UNITED STATES PATENT AND TRADEMARK OFFICE

APPLICATION NO.	FILING DATE	FIRST NAMED INVENTOR	ATTORNEY DOCKET NO.	CONFIRMATION NO.
10/629,825	07/30/2003	James R. Ellsworth	70869-0113US	7295
22902	7590	02/16/2006	EXAMINER	
CLARK & BRODY 1090 VERMONT AVENUE, NW SUITE 250 WASHINGTON, DC 20005			COOLEY, CHARLES E	
			ART UNIT	PAPER NUMBER
			1723

FINAL OFFICE ACTION

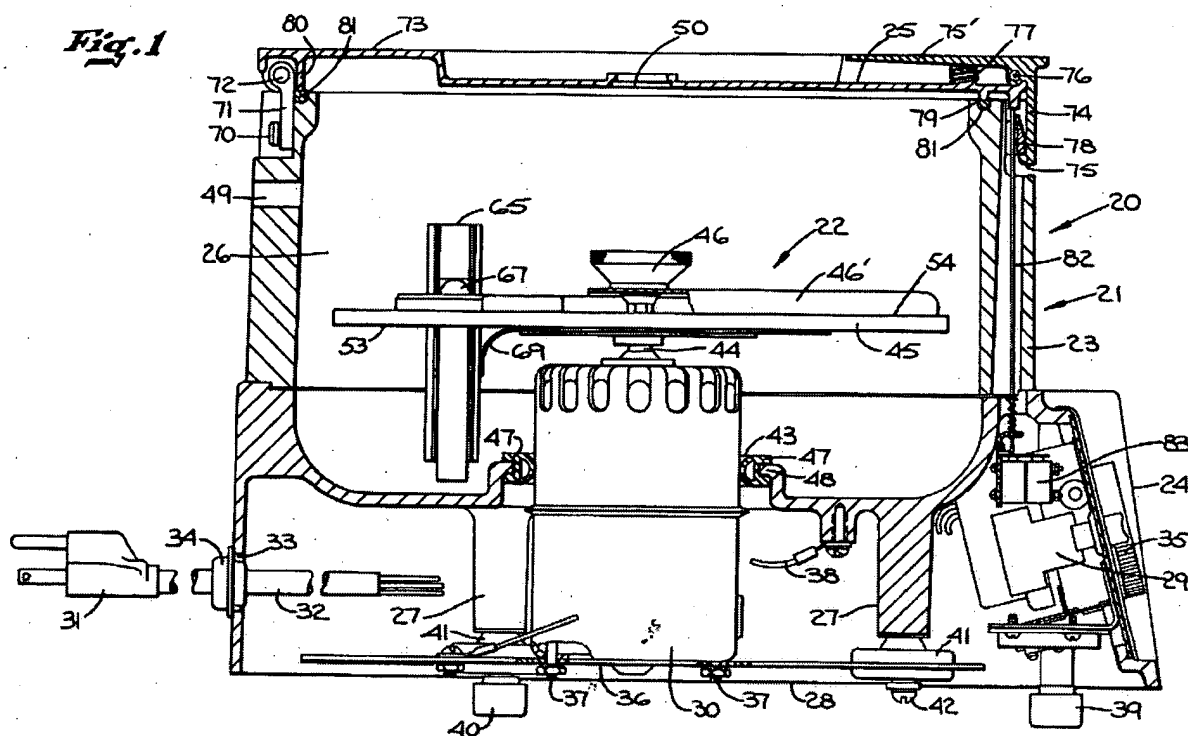
With regard to claims 1-2, the patent to Smith et al. discloses, as seen below, a centrifuge comprising a base 36 having feet 40; an enclosure 21, 26, 27 mounting a motor 30; a rotor 45 mounted on the motor; an isolator support 42 secured to the base 36 and extending between the base and the enclosure; a vibration isolator 41 mounted to the isolator support 42 and to a portion 27 of the enclosure 21, 26, 27; wherein said vibration isolator 41 engages said enclosure at a location that is substantially aligned with the force applied by said rotor resulting from imbalance of said rotor (col. 3, lines 37-41 and col. 7, lines 51-56).

With regard to newly presented claim 5, the patent to Smith et al. discloses, as seen below, a centrifuge comprising a base 36 "configured to" be supported on a stationary surface under the feet 39 and 40, an enclosure 21, 27 "configured to" support a rotor 45 and a drive mechanism 30; a support 42 mounted to said base 36 and extending away from said base to a location adjacent (i.e., below said rotor and within the centrifuge structure), and a vibration isolator 41 mounted to said support 42 at said location and to said enclosure.

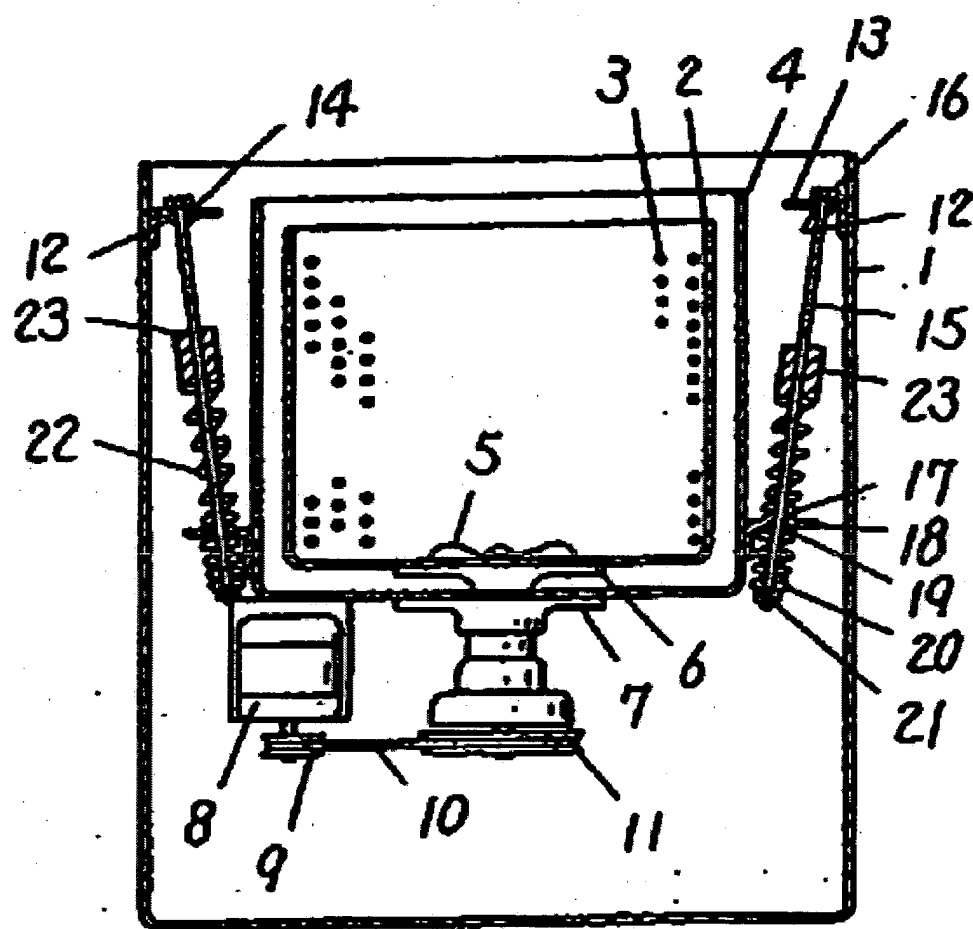
With regard to newly presented claim 5, JP 62-236593 discloses, as seen below, a centrifuge comprising a base 1 “configured to” be supported on a stationary surface, an enclosure 4 “configured to” support a rotor 2 and a drive mechanism 8; a support 13 and/or 15 mounted to said base 1 and extending away from said base to a location adjacent (i.e., laterally disposed with respect to the rotor or within the plane of rotation of the rotor 2), and a vibration isolator 22 mounted to said support 15 at said location and to said enclosure 4.

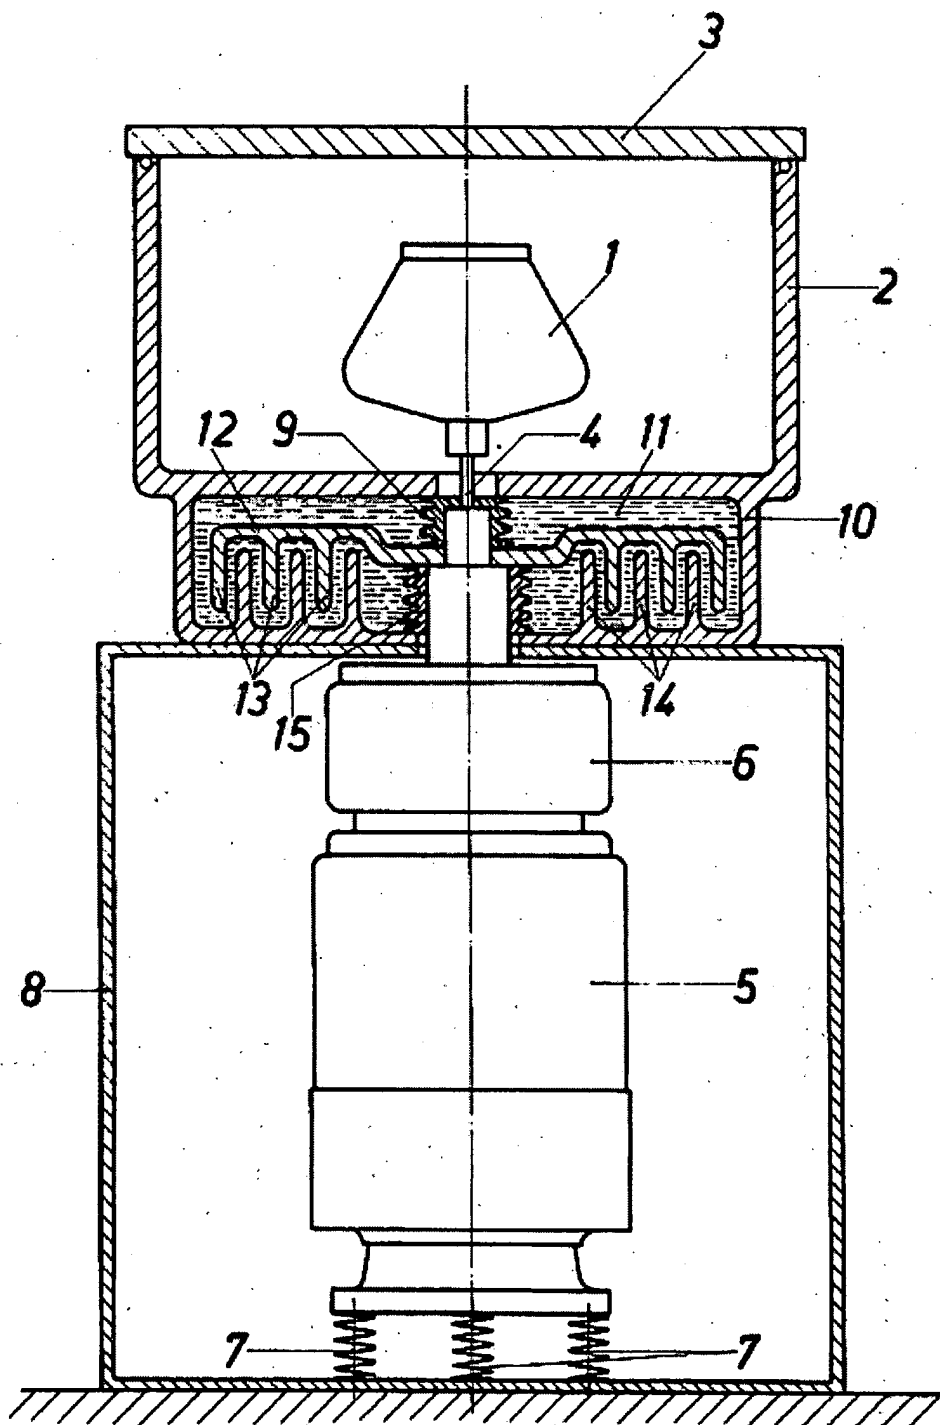
12. Claim 5 is rejected under 35 U.S.C. 102(b) as being anticipated by Stallmann (US 3,606,143).

With regard to newly presented claim 5, Stallmann '143 discloses, as seen below, a centrifuge comprising a base (below 7) "configured to" be supported on a stationary surface, an enclosure 8 "configured to" support a rotor 1 and a drive mechanism 5; a support 10 mounted to said base 8 and extending away from said base to a location adjacent (i.e., below the rotor 1), and a vibration isolator portion 11, 14 mounted to said support 10 at said location and to said enclosure 8.
